Economic Commission for Europe**Inland Transport Committee****World Forum for Harmonization of Vehicle Regulations****Working Party on Lighting and Light-Signalling****Eighty-ninth session**

UN Regulation No. 10 (Electromagnetic Compatibility)**Proposal for a new 07 series of amendments to UN Regulation No. 10 (Electromagnetic compatibility)****Submitted by the expert from by the Informal Working Group on Electromagnetic Compatibility***

The text reproduced below was prepared by the experts from the Informal Working Group on Electromagnetic Compatibility (IWG EMC), with the aim to develop a new 07 series of amendments to UN Regulation No.10. The proposed modifications to the current text of the UN Regulation are marked in bold for new or strikethrough for deleted characters.

"Figure 1d

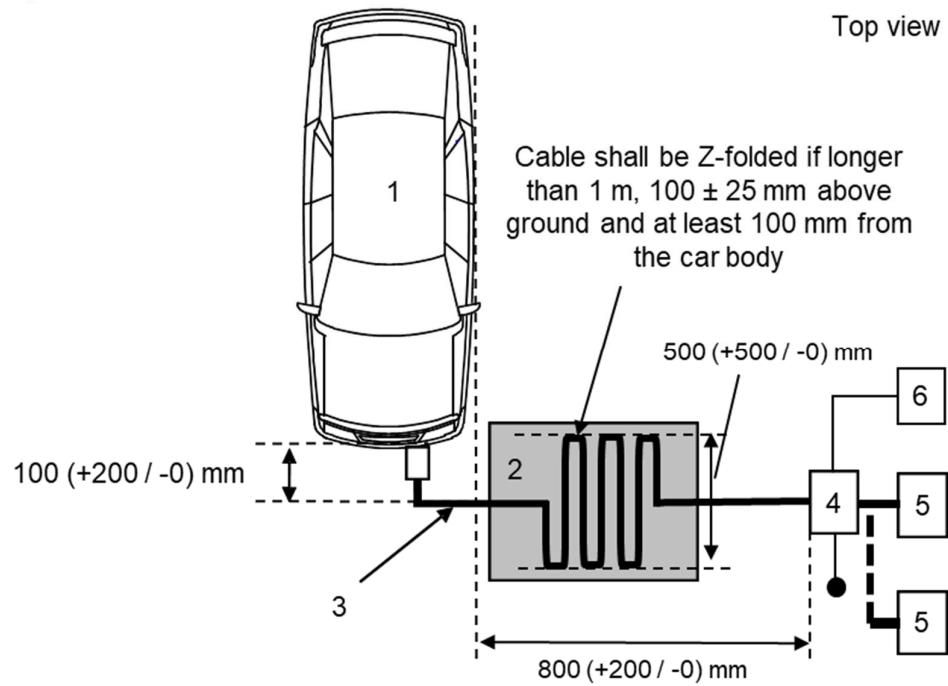
Figure 1d, amend to read:

Figure 1
Charging mode configuration for Annex 15"

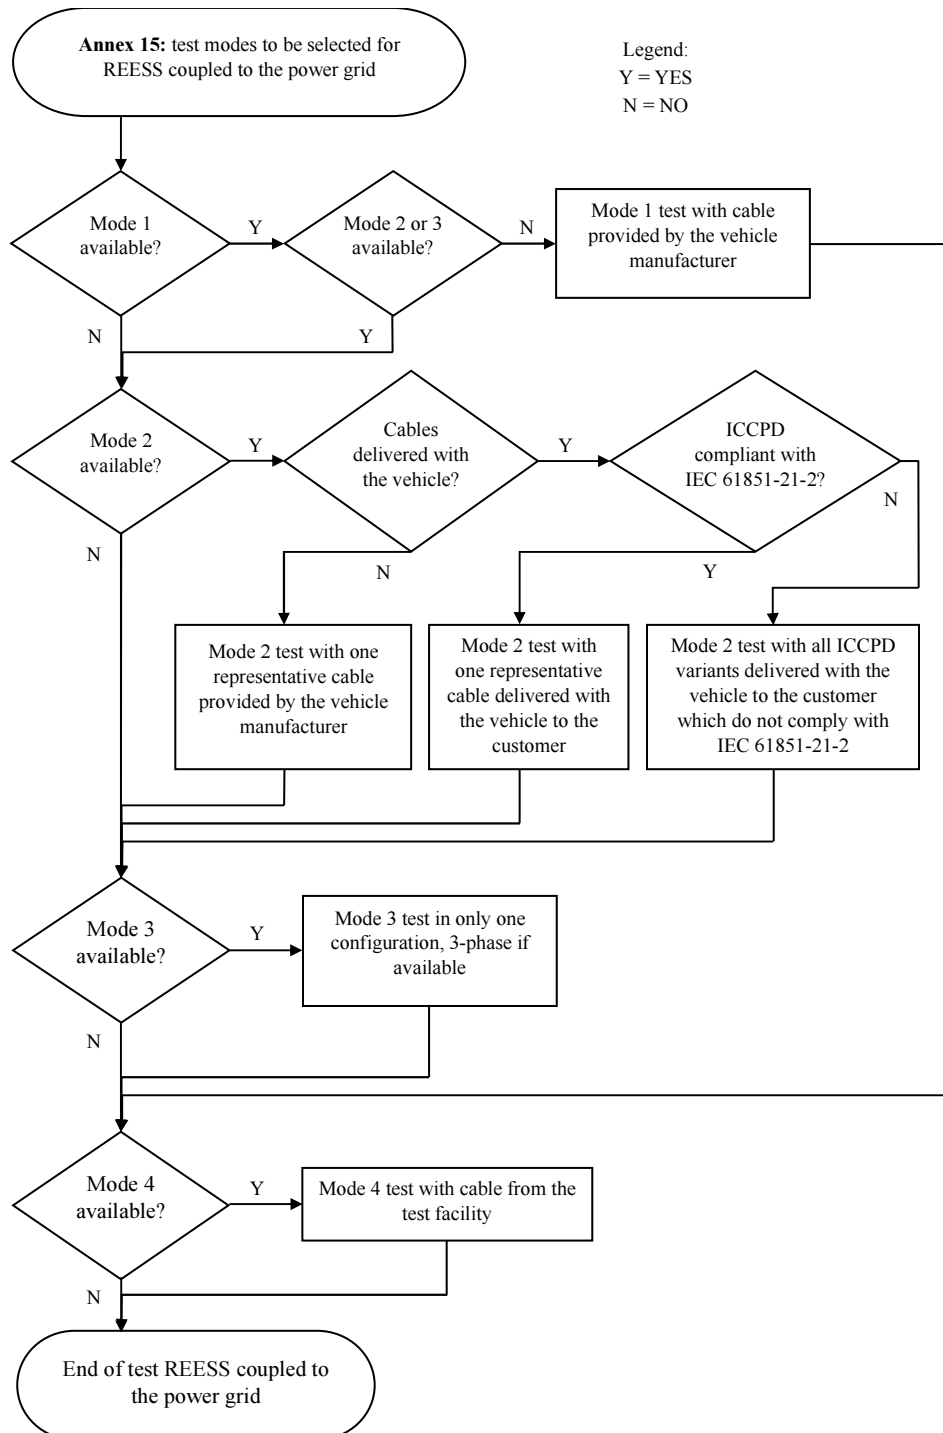
The vehicle shall be tested in the charging mode configuration (if available on vehicle) as defined in flowchart of figure 1

"Figure 1b

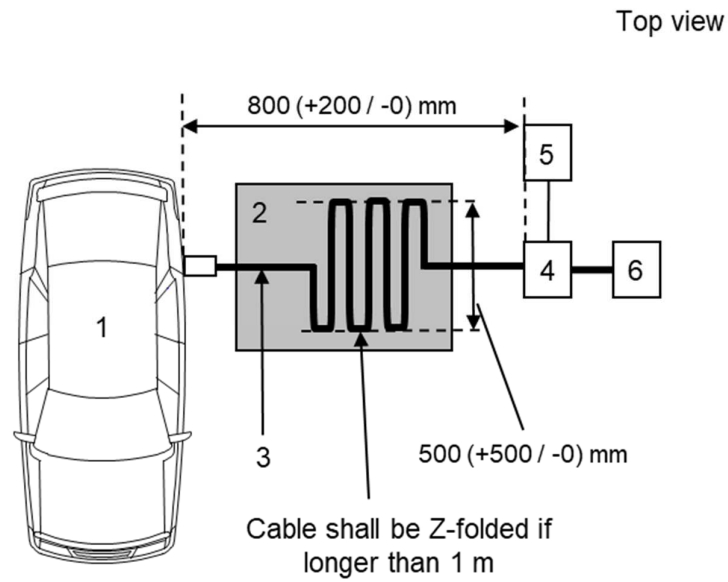
Figure 1b, amend to read:

"Figure 1d

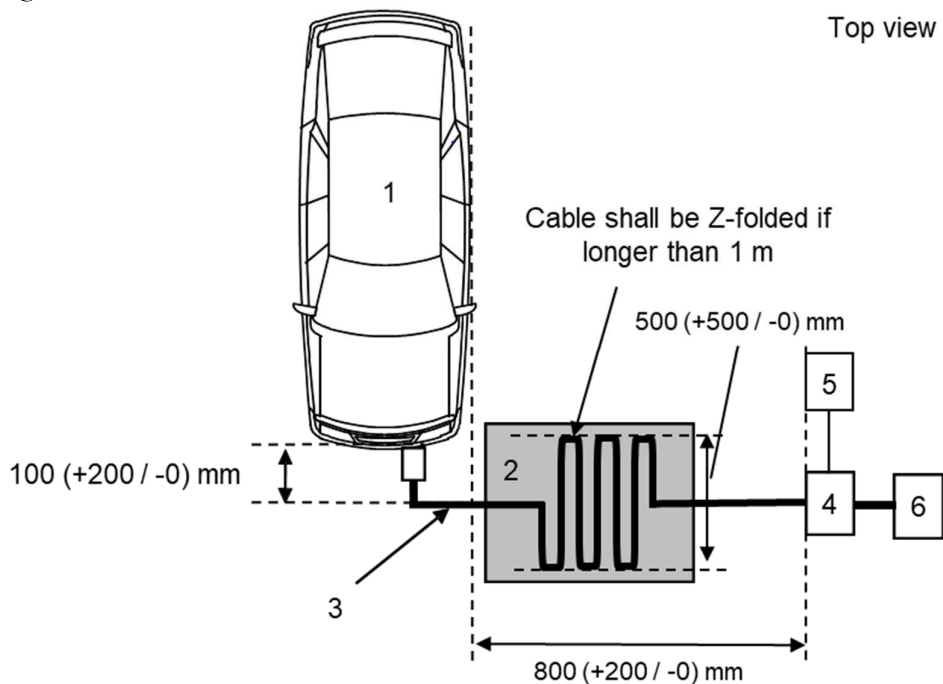
Figure 1d, amend to read:

Figure 1
Charging mode configuration for Annex 16"

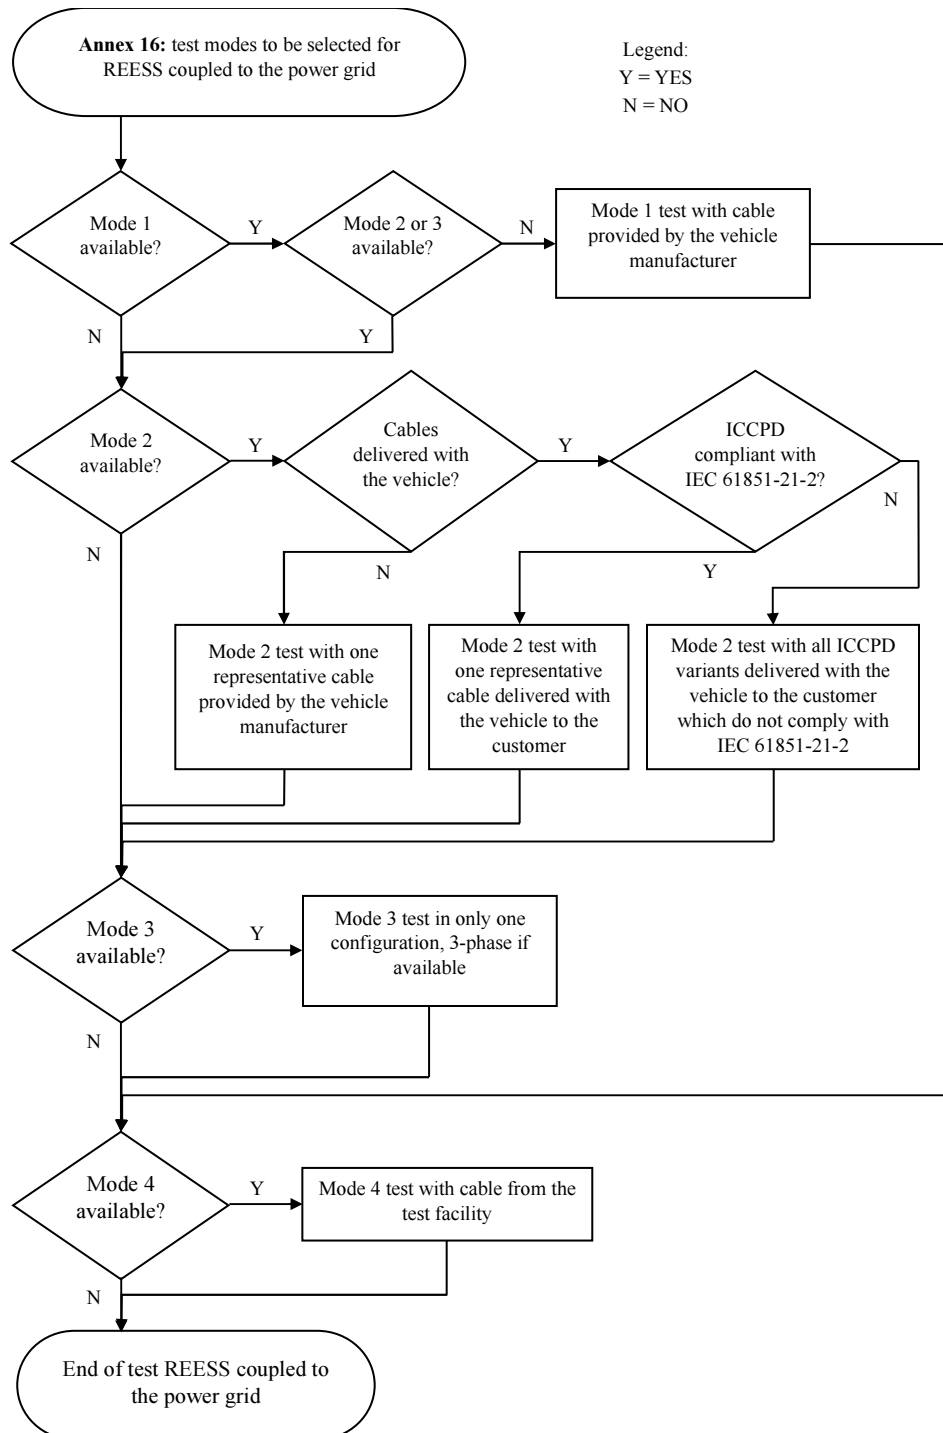
The vehicle shall be tested in the charging mode configuration (if available on vehicle) as defined in flowchart of figure 1

"Figure 1b

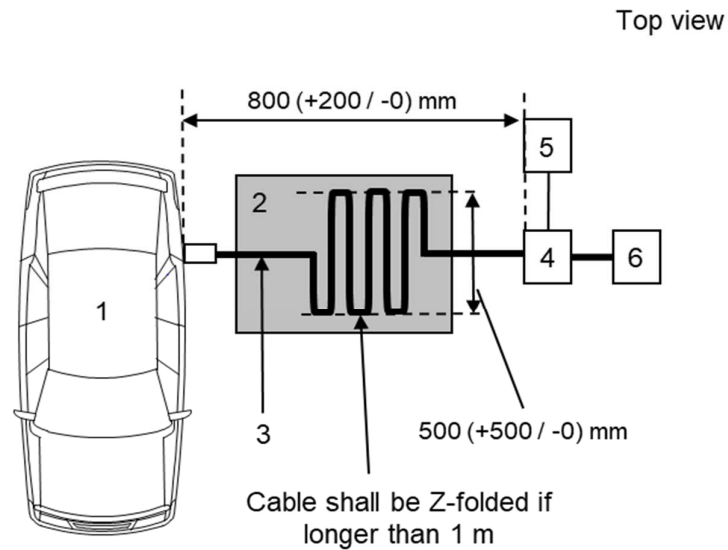
Figure 1b, amend to read:

"Figure 1d

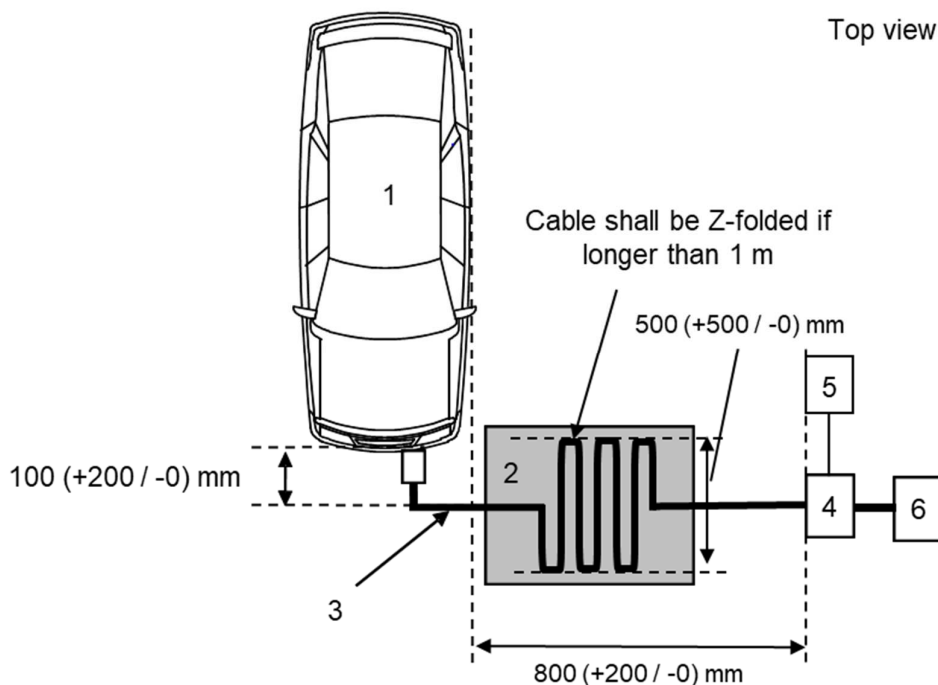
Figure 1d, amend to read:
